Eliza Yard – Jersey Street Ancoats
Design and Access Addendum
February 2024

13.02.24

Introduction

PROPOSED GROUND FLOOR PLAN

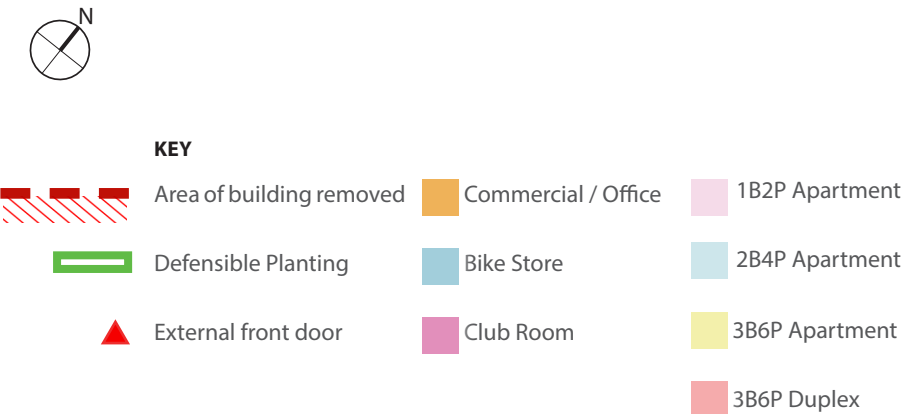
All corner balconies from ground to sixth floor have been removed from the scheme. As well as this, the external gable walls have been moved inwards by approximately 900mm to the western leg and by 1900mm to the eastern leg.

The dotted red lines on the floor plan to the right show the previous building footprint, indicating the reduction in overall footprint area.

As outlined in the introduction, 190m² of Class E Commercial Floorspace has been omitted from the Ground Floor arrangement. This along with some minor internal layout changes to the ground floor ancillary spaces, has allowed 4no. apartments to be created at Ground Floor to the North-Eastern elevations. The external front doors of these apartments will open out onto the future public realm zone in order to maintain a level of active frontage to this area. Defensible planting will be provided to create a buffer zone between the apartment front doors and the public realm. In addition, internal apartment entrance doors will be retained to these apartments, accessed from the communal corridor.

The club room has been omitted from the scheme, and the Bicycle Store has been relocated to it's position. Which ensures the fundamentals of the cycle access strategy to be unchanged.

PROPOSED TYPICAL UPPER FLOOR PLAN

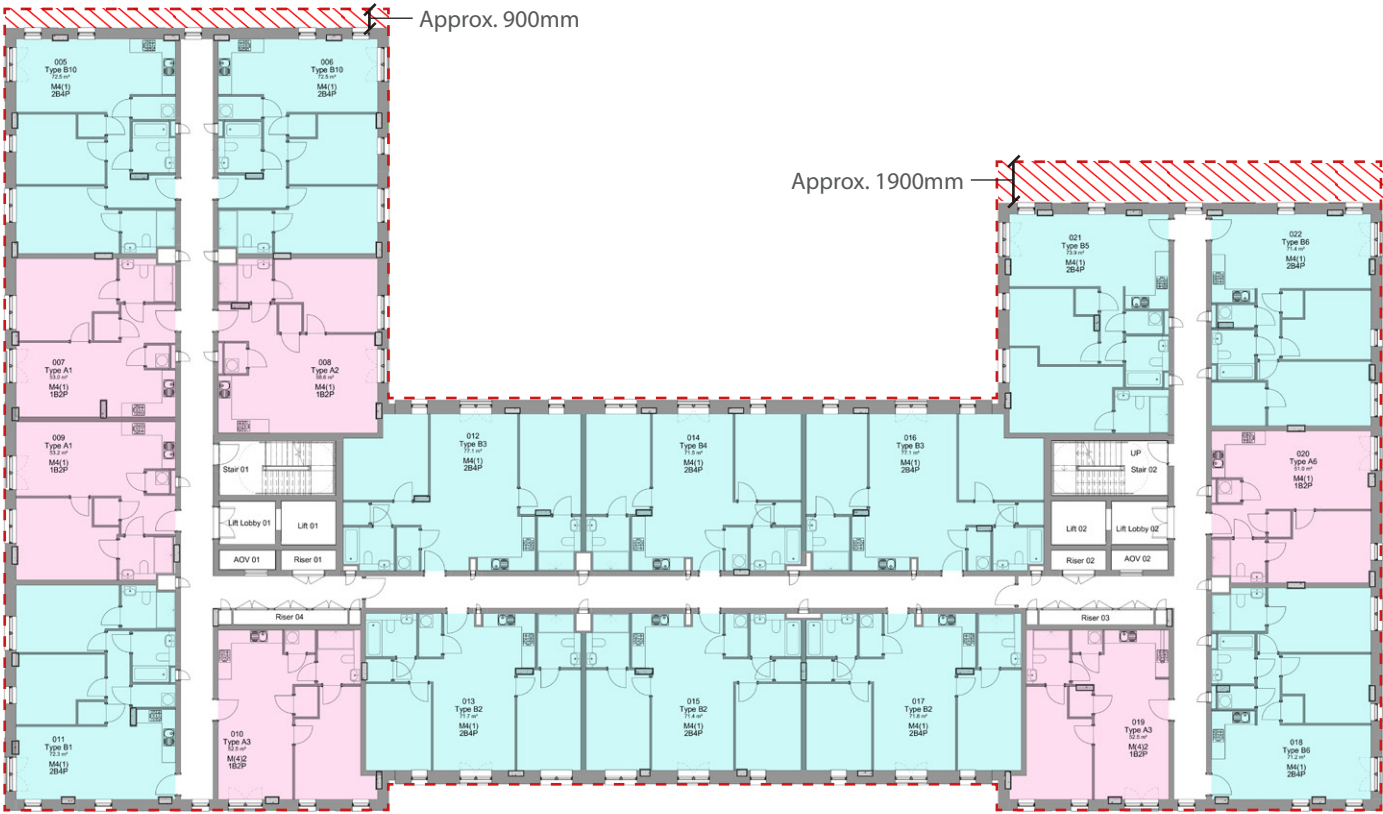
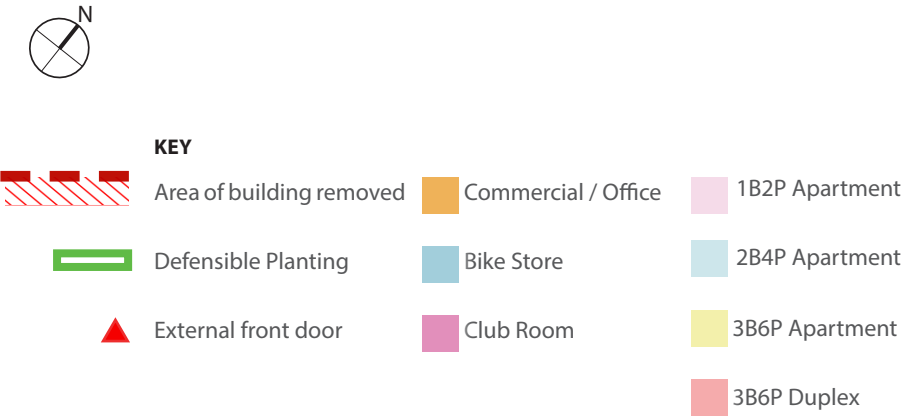
The consented and proposed plans on this page indicate the removal of all balconies to the façades, and the alterations to the west and eastern gable positions. The red dotted line indicates the previous building footprint.

The unit mix remains unaltered on a typical floor. Location of party walls and internal layouts have been updated in areas to offset the area gained by the removal of the balconies.

In lieu of what would have been balcony doors, large Juliette glazing has been retained to the apartments to activate the elevations and provide well lit internal spaces. Strong corners are reinforced by brick piers coming to ground and rooting the concept of the solid brick gables which take influence from the surrounding historic industrial buildings.

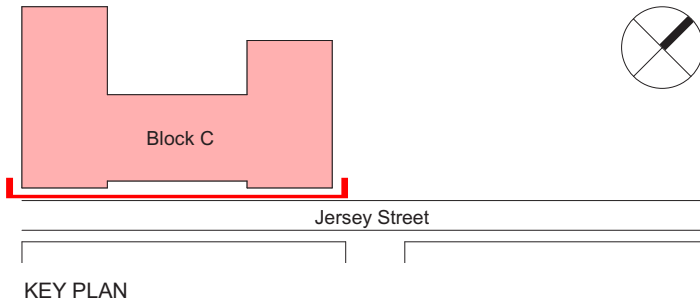
The opportunity to increase the number of apartments in the scheme to aid viability was the driver to reduce the original Seventh Floor plan set back.

To ensure the design principles of the approved scheme are worked to, a reduced set back has been retained. This continues to provide variation and activity to the facade and maintains the original architectural language as closely as possible.

PROPOSED 3D MASSING

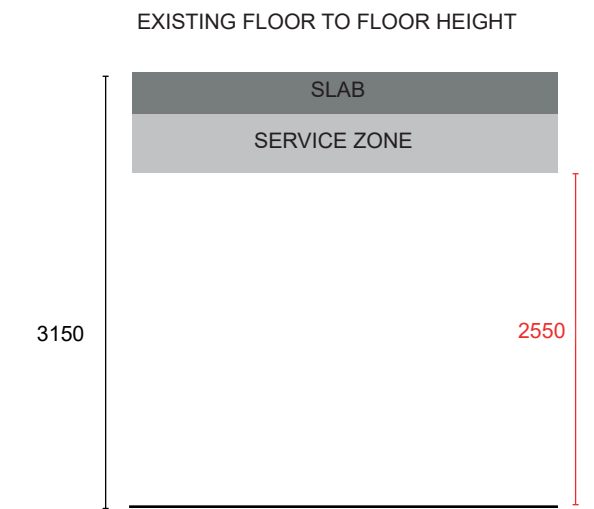
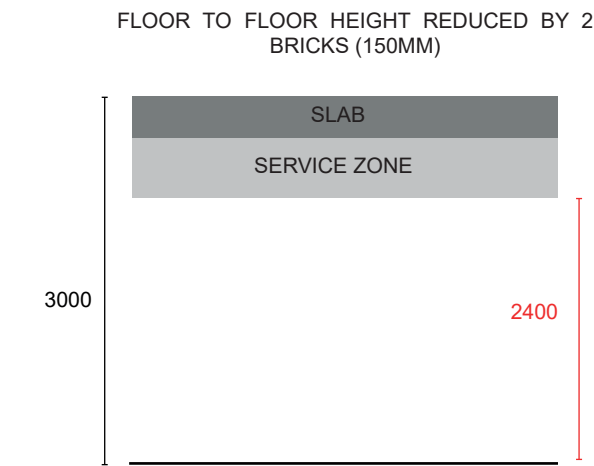
2no. brick courses (150mm) have been reduced to storeys 1 - 7, which results in an overall 1050mm reduction to the parapet line of the building.

Pursuant to this, the floor to ceiling height of the residential units is reduced from 2550mm to 2400mm. This remains in accordance to the Manchester Residential Quality Design Guidance. Diagrams of which are illustrated to the following pages.

The building corner balconies are omitted and replaced with Juliette balconies, with the corners remaining to be reinforced with brick piers to ground.

The other main alteration to the elevations is to the North - Eastern perspective, where at ground floor the commercial unit has been omitted and replaced by apartments. The architectural approach therefore, has been amended to a more domestic appearance reflecting its use.

Front doors are provided to these apartments to provide a level of active frontage onto the proposed green corridor and future public realm.

KEY PLAN

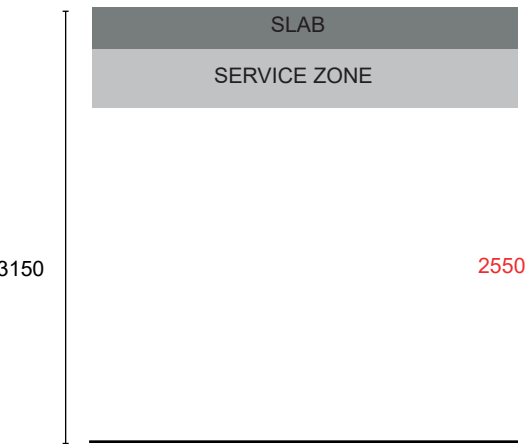
The South, West and North Elevations are largely unaffected by internal layout changes, and all materials to the facade remain the same as the consented application.

Minor changes to these elevations, are a result of the balcony removal to the corners and a reduction in the floor to floor height from 3150mm to 3000mm.

On the Seventh Floor, the proposed window openings have been aligned with the new apartment layouts and follow the same rhythm as the lower floor window proportions and locations.

PROPOSED EAST ELEVATION

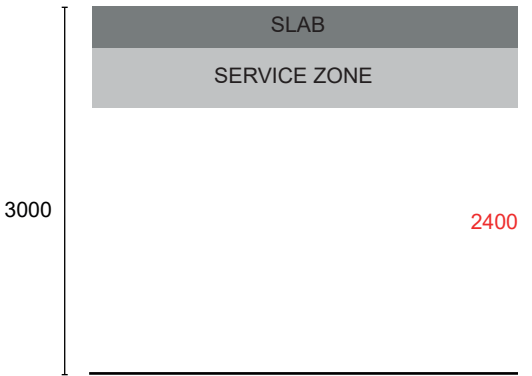
As the previous page, changes to the elevations generally, are a result of the balcony removal to the corners and a reduction in the floor to floor height from 3150mm to 3000mm.

In addition, on the East elevation, where the commercial unit has been omitted from the Ground Floor and replaced with apartment units, it was felt that the architectural approach should be updated here to reflect a more residential frontage rather than a full height glazed aesthetic.

Therefore, the architectural detailing of the projecting brick banding has been continued to ground to this elevation.

FLOOR TO FLOOR HEIGHT REDUCED BY 2 BRICKS (150MM)

PROPOSED WASTE STRATEGY DIAGRAM

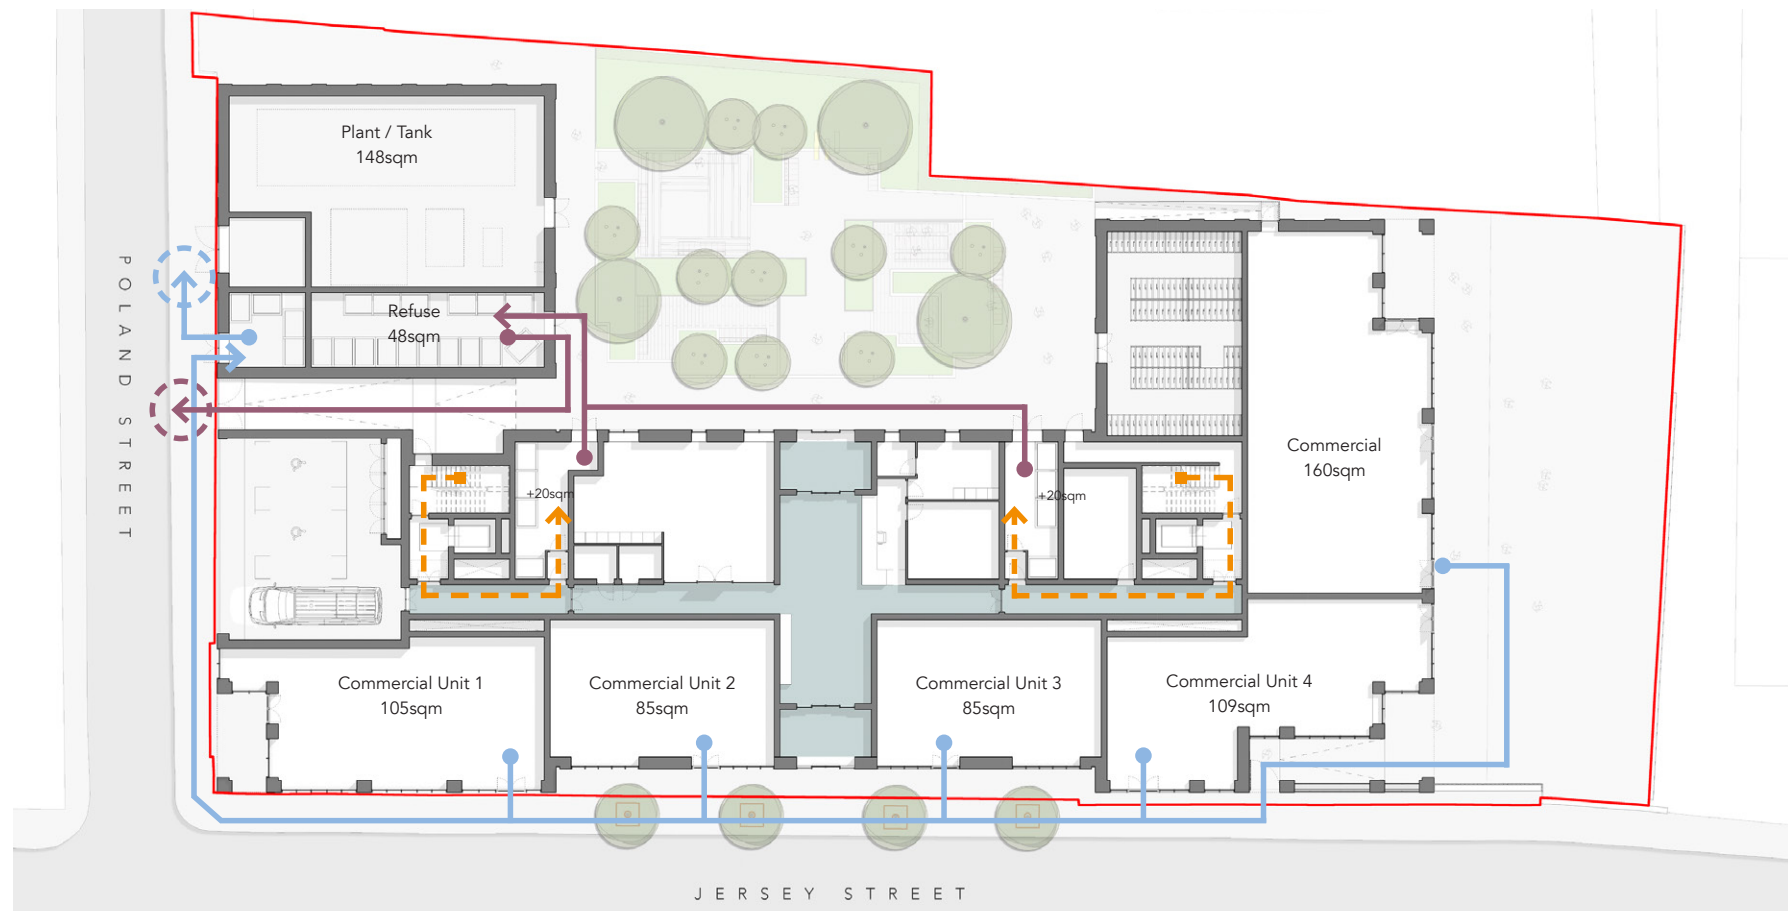
As the number of apartments has slightly increased from the consented scheme, the required number of residential waste provision has increased.

There are 3no. refuse stores located across the Ground Floor of the development. Refuse Store 2 and 3, are located adjacent to the entrance and stair cores, allowing residents to travel downstairs and dispose of waste without having to leave the building.

The larger Refuse Store 1, will be controlled by building management, rotating empty and full bins between Store 2 & 3 with the main holding Store 1. This arrangement is as approved under the original application consent.

The commercial refuse store has remained the same size and provision, despite the decrease in commercial floorspace. This is to ensure that adequate provisions for each individual commercial unit is allowed for.

The MCC document, *GD 04 Waste Storage and Collection Guidance for New Developments Version 6* states that the development needs to provide 0.43m² of refuse space per apartment. Therefore the minimum space requirements for the refuse storage will be 54.5 sqm. Eliza Yard provides a total of 92 sqm of refuse store, so exceeds this guideline. This accommodates 26no. 1100L residential refuse bins in the scheme, plus 4no. 240L bins for food waste.

An additional 17 sqm accommodates 4no. 1100L commercial refuse bins for the scheme - 1no. Euro-bin per commercial unit.

EXISTING CYCLE ACCESS STRATEGY DIAGRAM

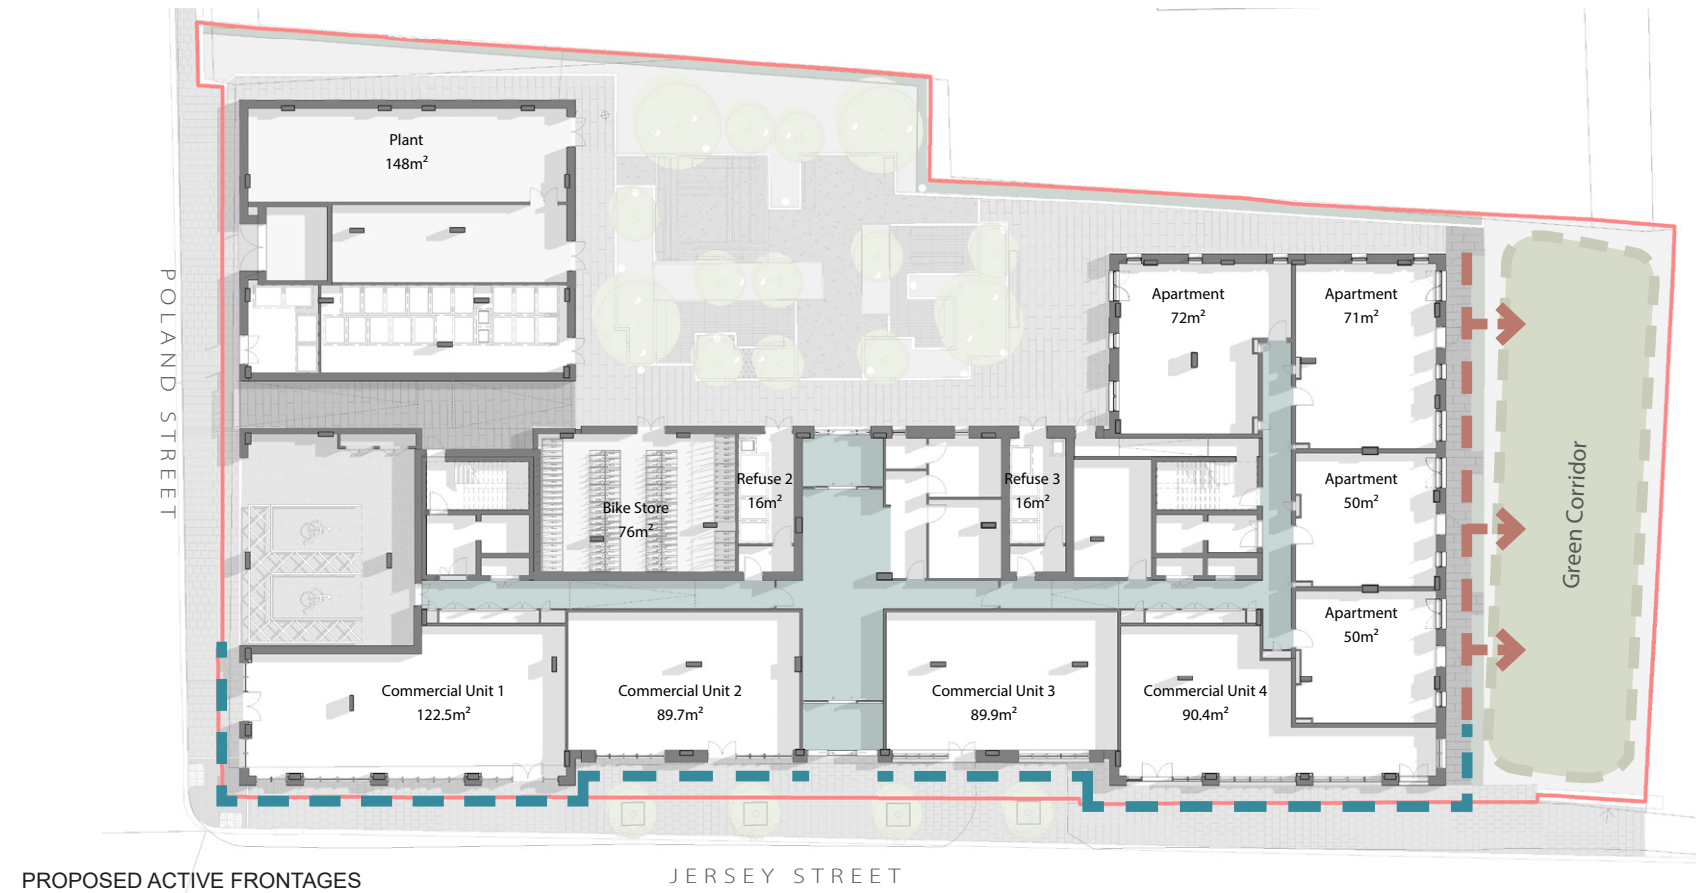
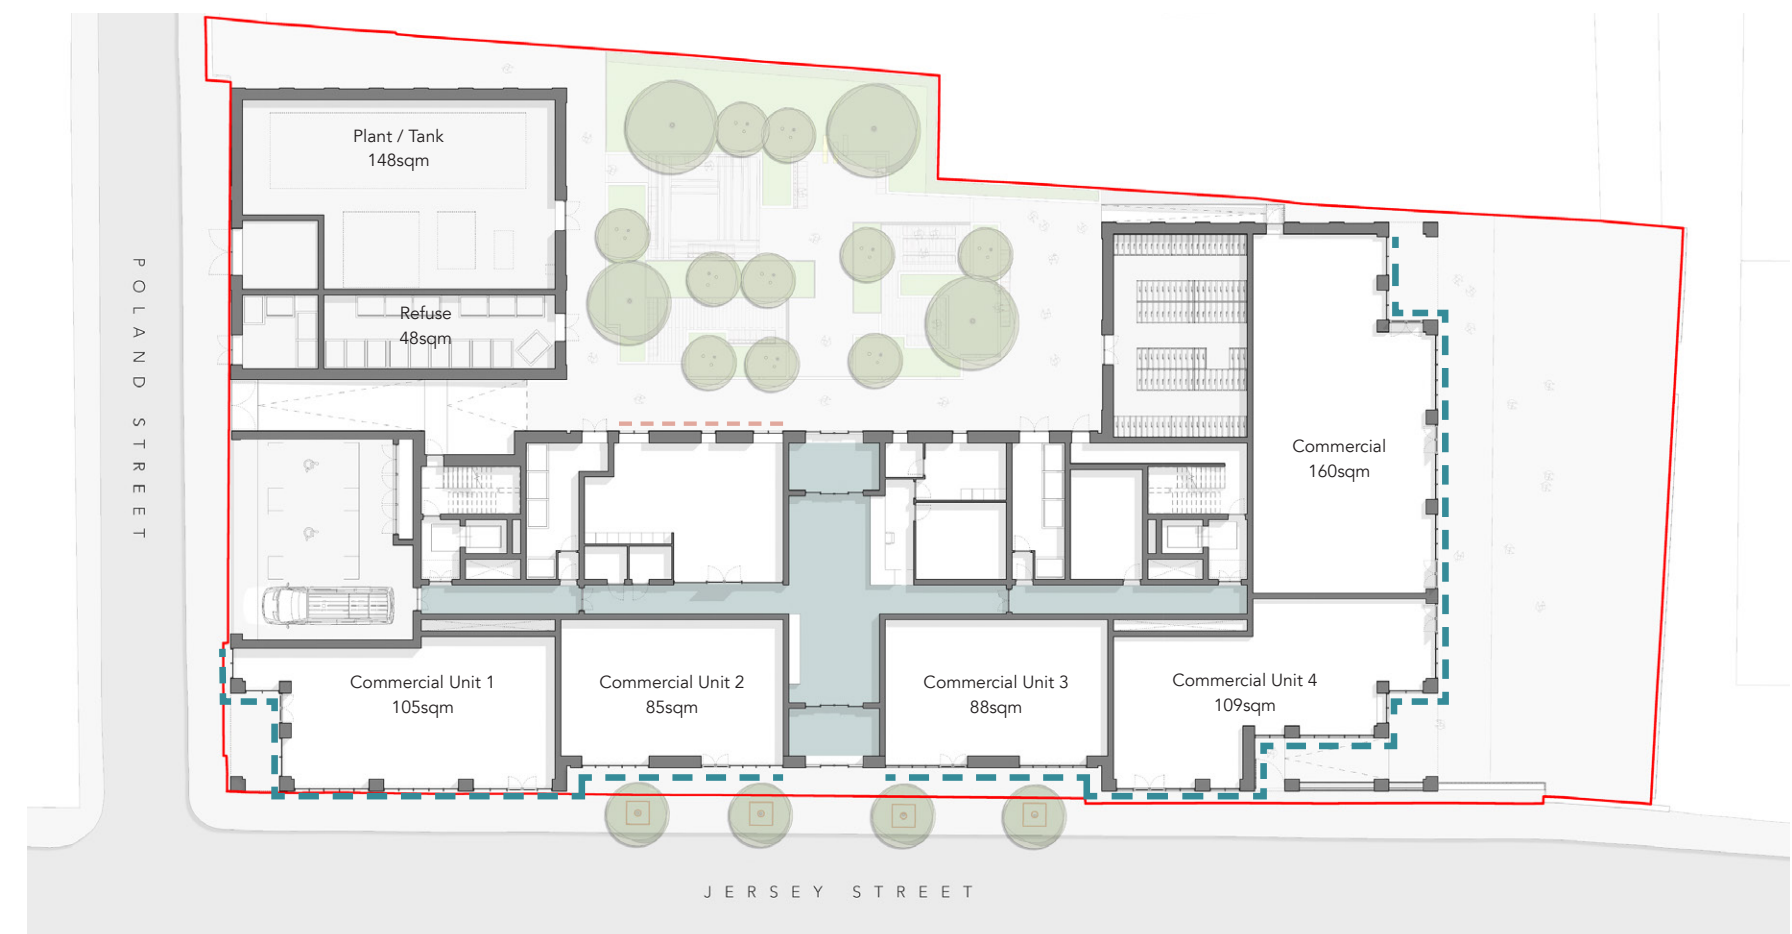
As the number of apartments have increased by 8no., this has been reflected in the number of cycle storage required in the development.

The bicycle store will include a space for one bike per apartment, doubled stacked.

In addition, the Bicycle Store position has been relocated to an accessible location adjacent the rear building entrance and directly off the gated route from Poland Street. This allows residents to walk their bike easily through the yard and preventing the need to push bikes through the entrance lobby.
